Subject: SAS-Multiple Connections on Wide Ports

Placing connections on SAS ports with multiple links is not very well defined in SAS rev 01. This is a proposal to add in figures and text into the model section on SAS that describes that function.

Figure 1 — Multiple connections example

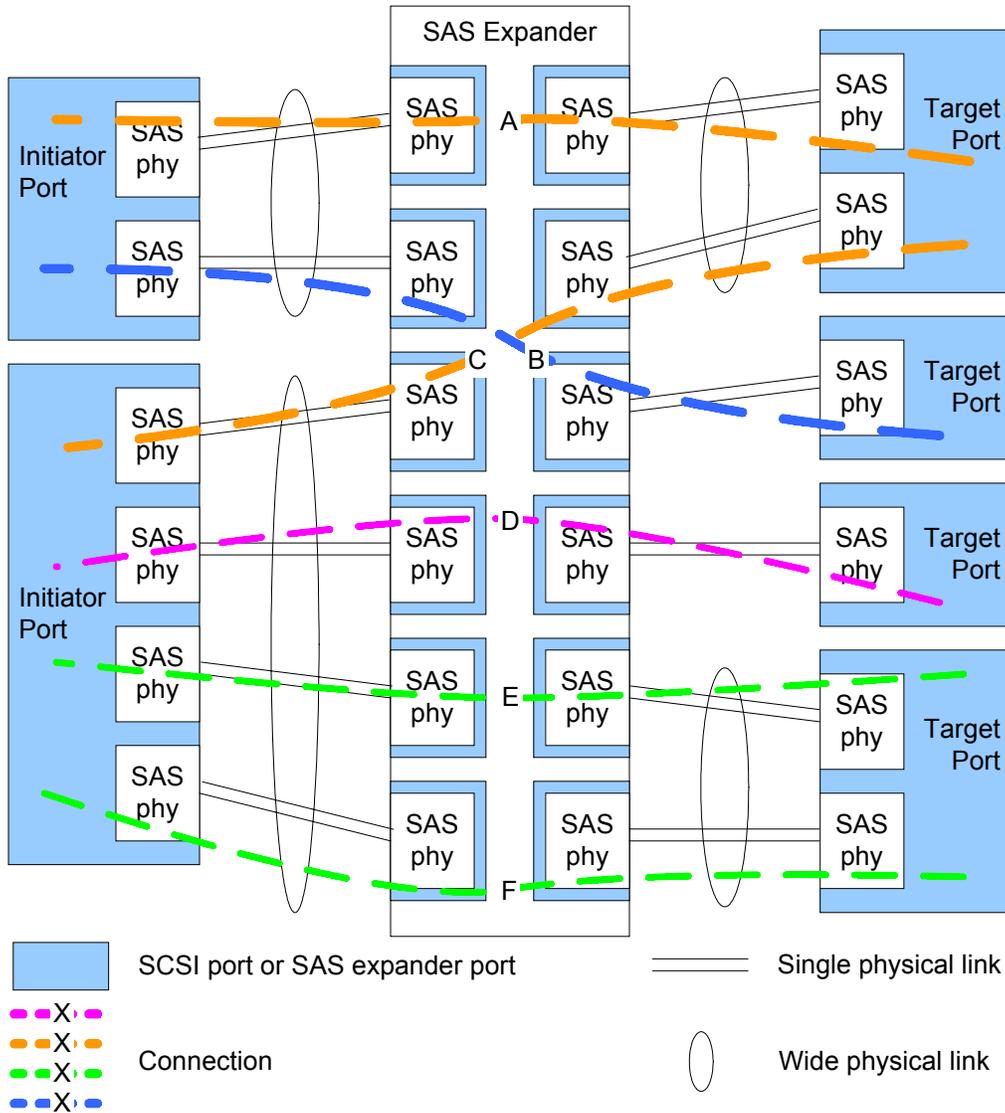
See figure 1 for examples of connections between wide ports.

In figure 1 all the connections shown may occur simultaneously.

In figure 1:

- a) the connections labeled A and B are an example of one initiator port with connections to multiple target ports;
- b) the connections labeled A and C are an example of one target port with connections to multiple initiator ports;
- c) the connections labeled E and F are an example of multiple connections between the same initiator port and target port; and
- d) the connections labeled C, D, E, and F are an example of one initiator port with connections to multiple target ports with one of those target ports having multiple connections with that initiator port.
